MEMORANDUM

TO: District of Columbia Zoning Commission

DATE: May 19, 2014

SUBJECT: Zoning Commission Case No. 13-18: **Final Report** for a Consolidated Planned Unit Development and Zoning Map Amendments for Square 5925 at 4129-4131 Wheeler Rd. SE

Future Land Use Map

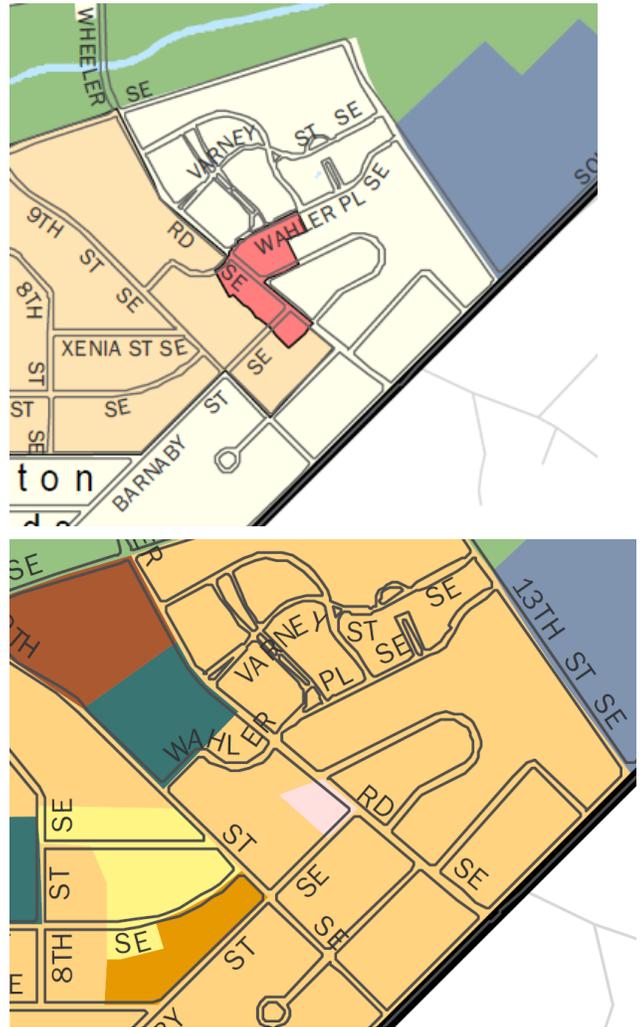
The Future Land Use Map designates the subject site for low density commercial uses. Although zones corresponding to this designation include C-1 and C-2-A, other zones may apply. This map provides generalized guidance, and is to be read in combination with the Policy Map and Comprehensive Plan policies.

Typically, the Office of Planning would have difficulty supporting C-2-B zoning for a property designated for low density development. The C-2-B zone is not typically considered a low density zone anticipated under the Future Land Use Map, and the proposed height and density are slightly beyond what is normally expected in an area designated for low density development. However, read in tandem with the Generalized Policy Map, which designates the site as a Neighborhood Commercial Center, and other Comprehensive Plan statements, the proposed development is considered appropriate in this case.

A more typical zone for this Land Use Map designation, C-2-A, would allow 3.0 FAR and 65 feet height maximum. This would have limited the ability to provide the high level of housing affordability, the quality ground floor retail space, and contemporary design that the project seeks to attain. The Generalized Policy Map encourages housing and retail opportunities in mixed-use infill developments. In this particular case, these factors in combination encourage "the application of other zone districts", as stated in the Comprehensive Plan language (225.8.) and should not be interpreted as a precedent for future cases.
